ADDENDUM 2 – JOB 23335

TO: All prospective bidders on Projects NHU-SU-CPU-7-002(178)019, Job No. 23335 scheduled for the January 10, 2025 bid opening.

PLAN ADDENDUM SUMMARY AND APPROVAL

PROJECT INFORMATION		
Project:	NHU-SU-CPU-7-002(178)019	PCN: 23335
Location:	US-2 9 th Ave W to N of 34 th St in Williston	
Date:	12/27/2024	Lead Designer: Civil Science
Bid Opening Date:	1/10/2025	JOB#: 23335 Addendum#: 2

Lighting Schematic
Existing Feedpoint "EXFP1"

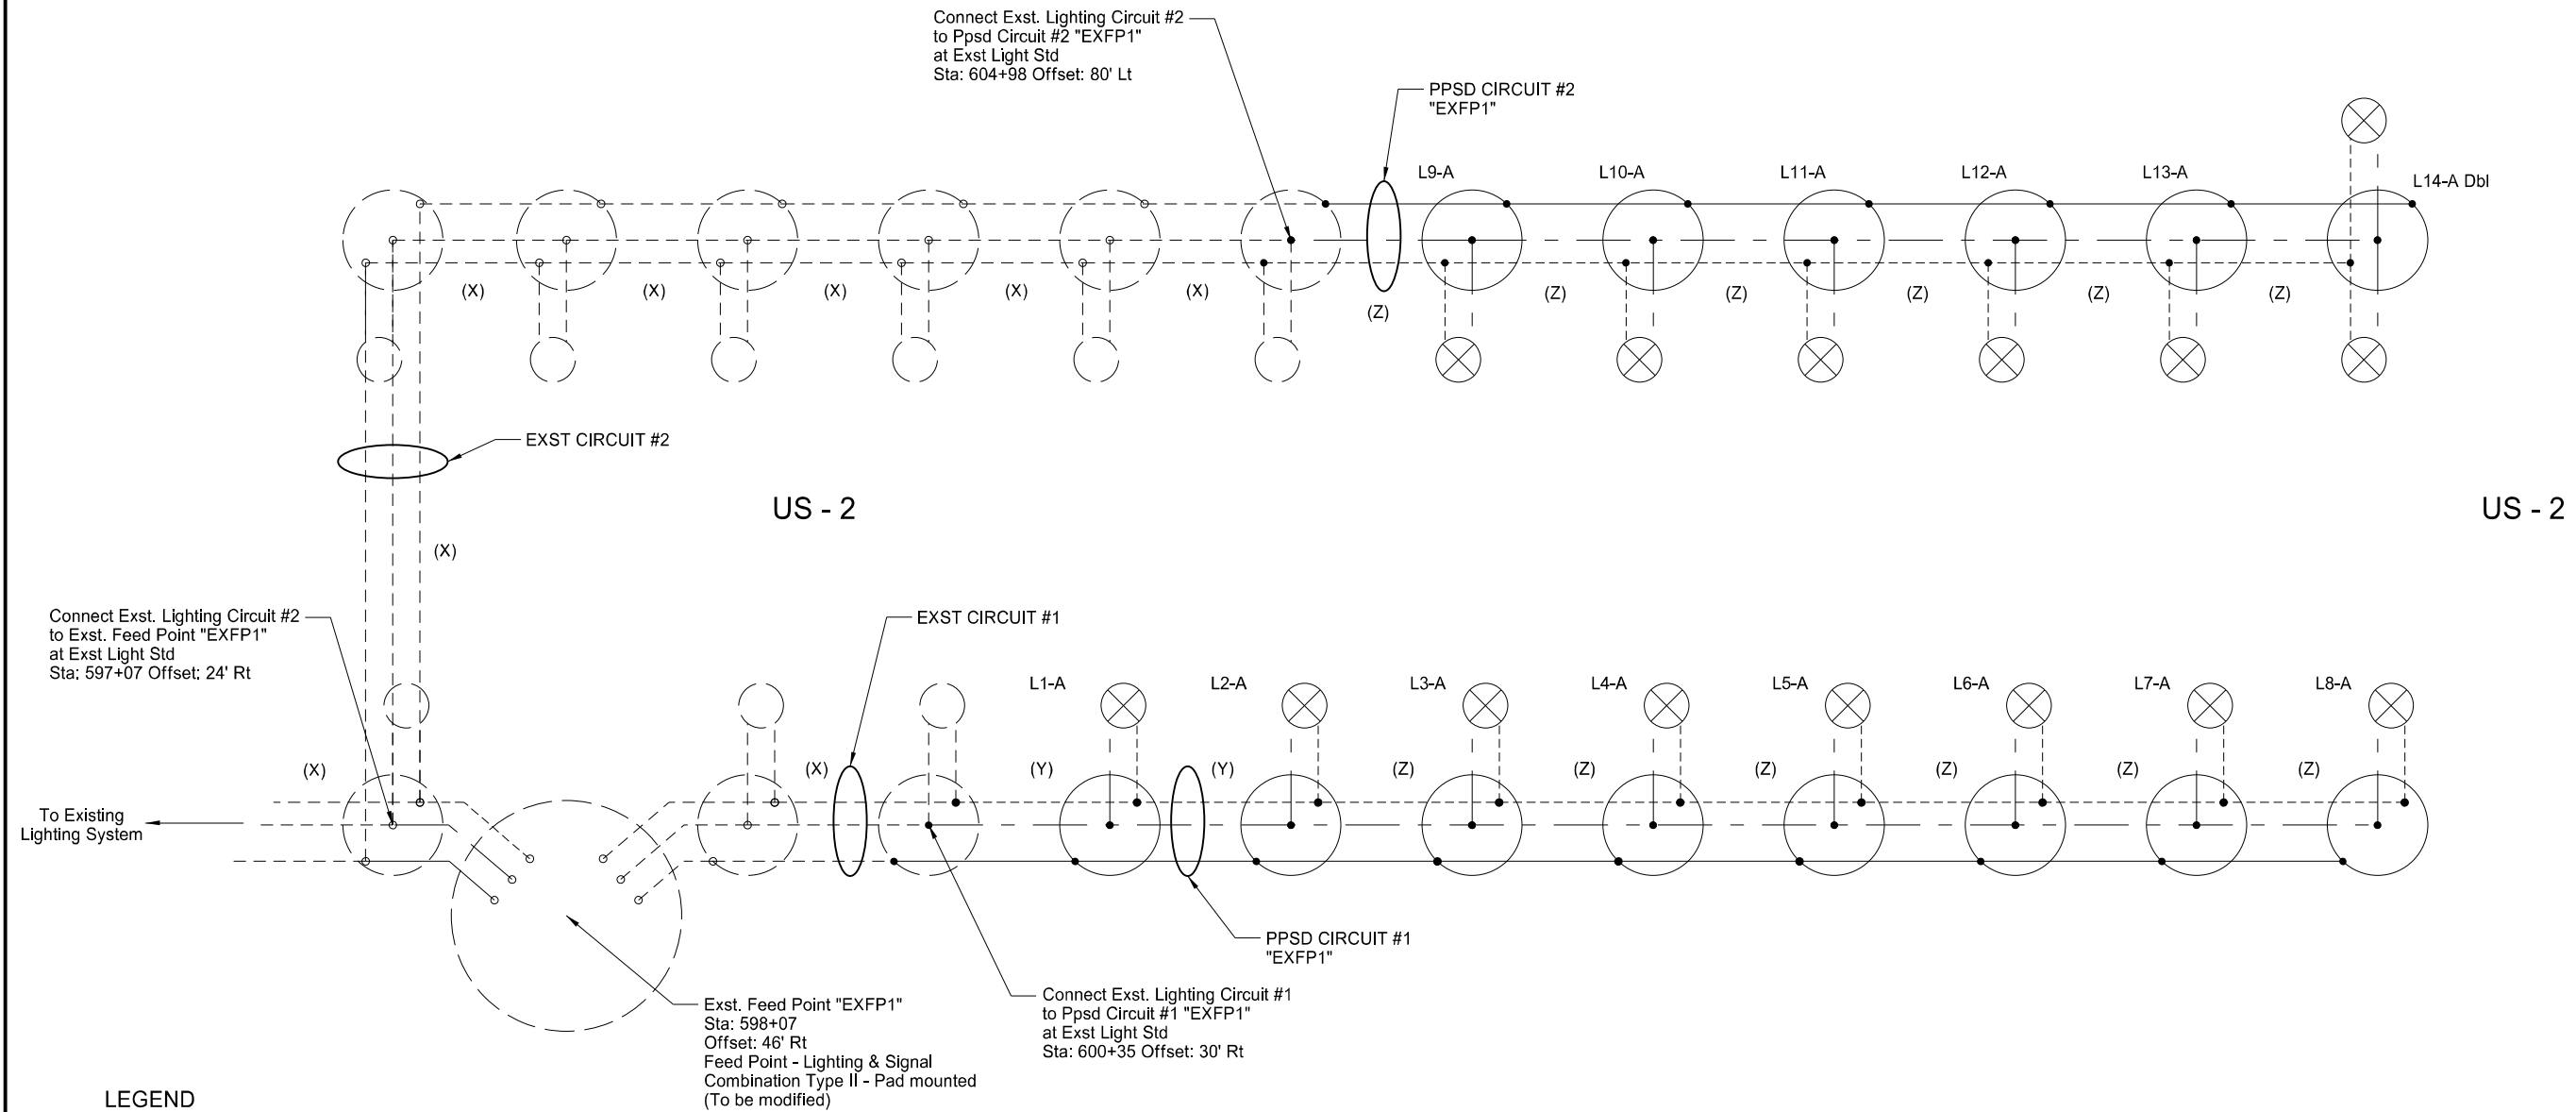
140	16	Revised Light Std L71 to a Type A Dbl.
140	20	Updated EXFP1 lighting schematic to show Ppsd Cirtcuit #1 including Luminaires L1 to L8, and Ppsd Cirtcuit # 2 including Ppsd luminaires L9 to L14.
140	23	Updated FP3 lighting schematic to show a Type A Dbl at Light Std L71.
140	24	Updated quantity table for Existing Feedpoint "EXFP1" at US-2 & 9 th Ave W based on revised circuit layout and removal of pull boxes LHT-PB1 and LHT-PB2.
140	26	Updated quantity tables for Proposed Feedpoint "FP3" at 2 nd Ave W & 26 th St W and Light Standard Locations Fed from FP3 at 2 nd Ave W & 26 th St W to show "L71-A" being revised to "L71-A Dbl". Updated lighting quantities summary table for the changes to "EXFP1" and the revision of L71 to a Type A Dbl. Removed quantities for Embedded Foundation. Total quantity for Concrete Foundation revised to 77.
150	6	Revised "Controller Type 1" in Quantities table to "ATC Controller and Cabinet". "Vide Detection Equipment" revised to "Video Detection Equipment".

Revised	12/27/2024	STATE	PROJECT NO.	SECTION NO.	SHEET NO.
		ND	NHU-SU-CPU-7-002(178)019	150	9

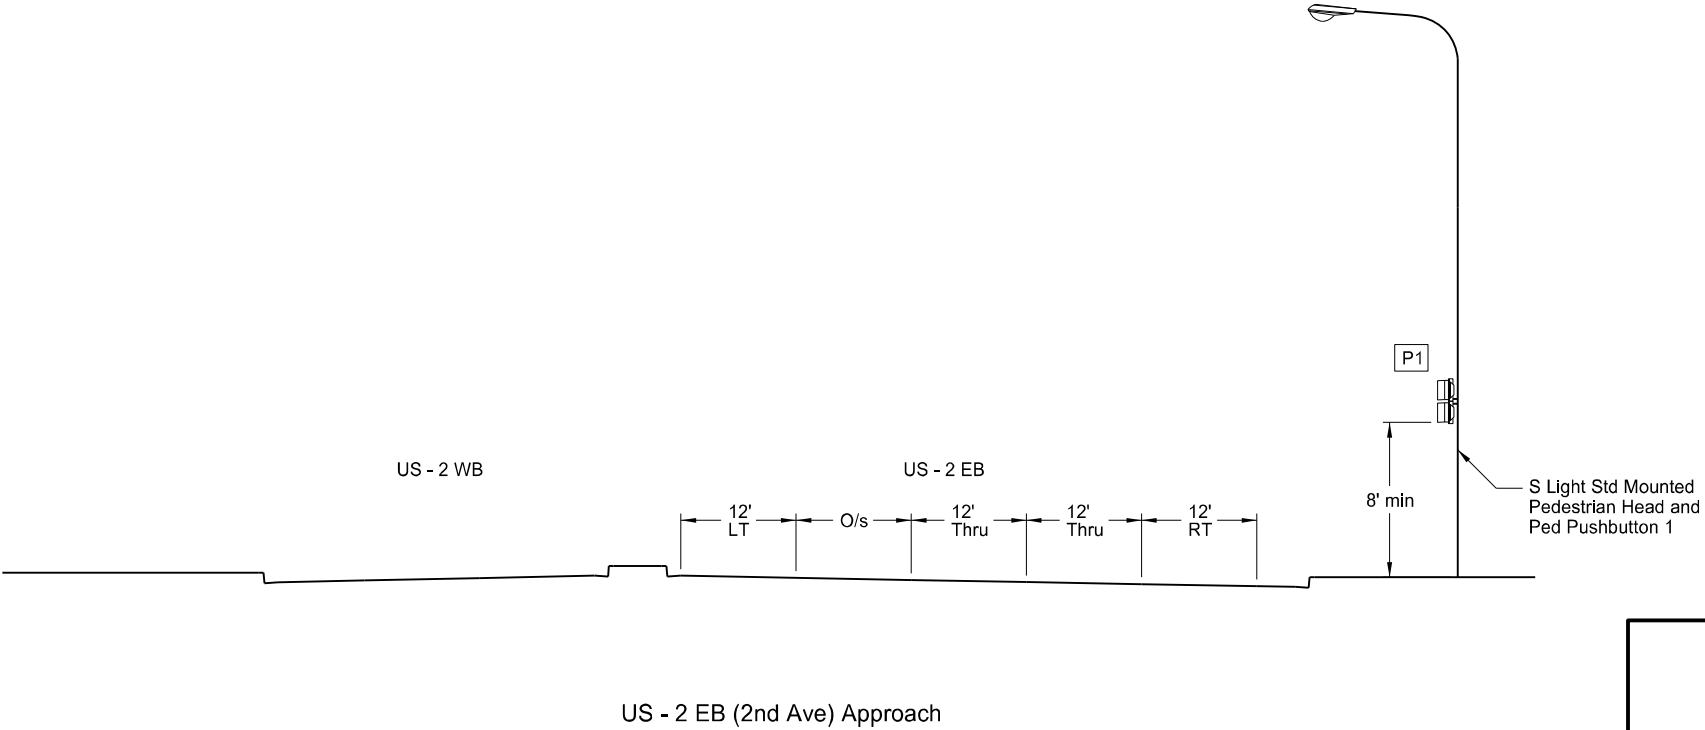
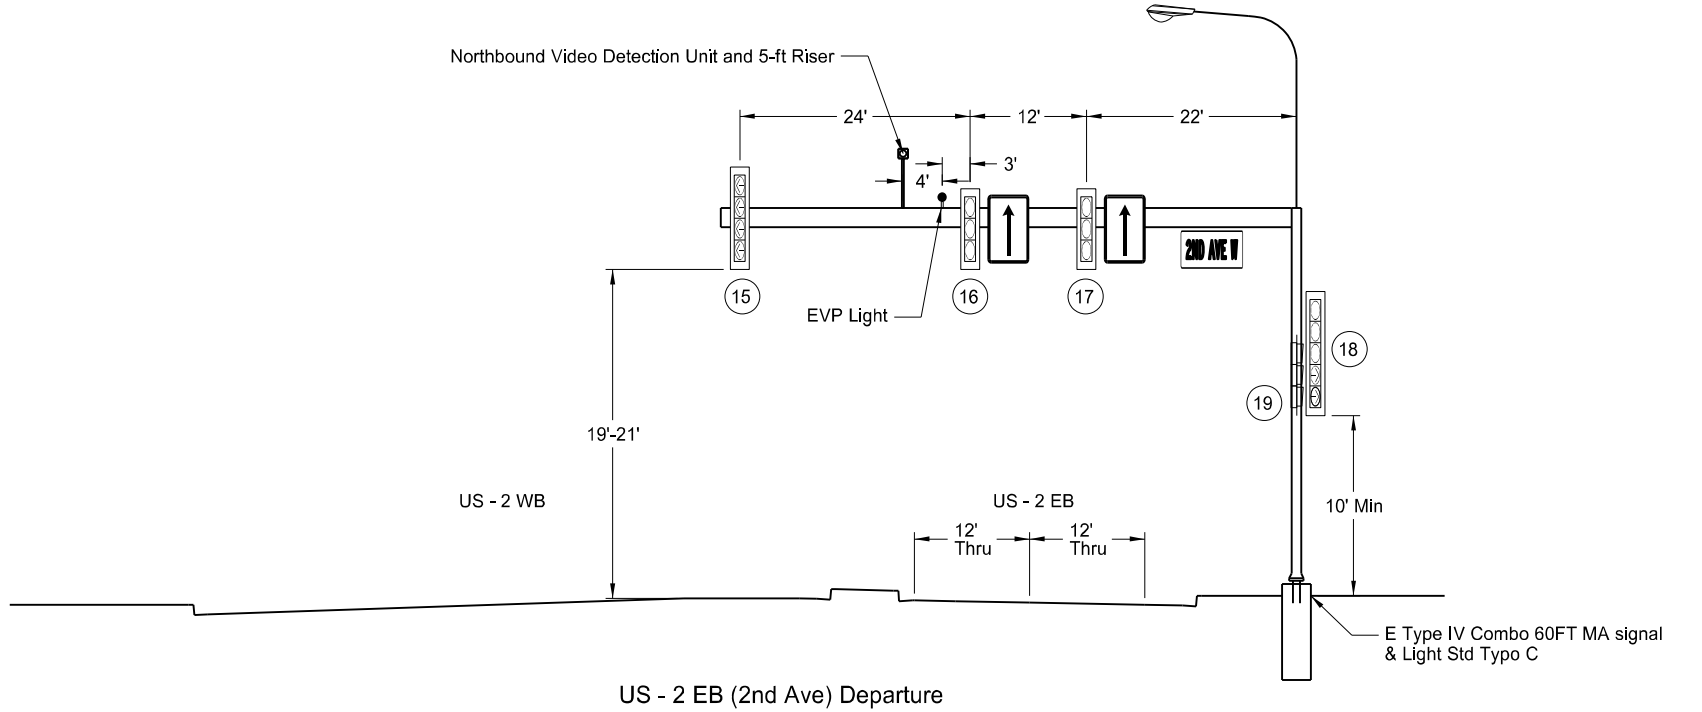
150	9	Revised vertical clearance dimension to call out 19'-21'.
150	10	Revised vertical clearance dimension to call out 19'-21'.
150	11	Revised vertical clearance dimension to call out 19'-21'.
150	12	Revised vertical clearance dimension to call out 19'-21'.
150	19	Revised "Controller Type 1" in Quantities table to "ATC Controller and Cabinet".
150	22	Revised vertical clearance dimension to call out 19'-21'.
150	23	Revised vertical clearance dimension to call out 19'-21'.
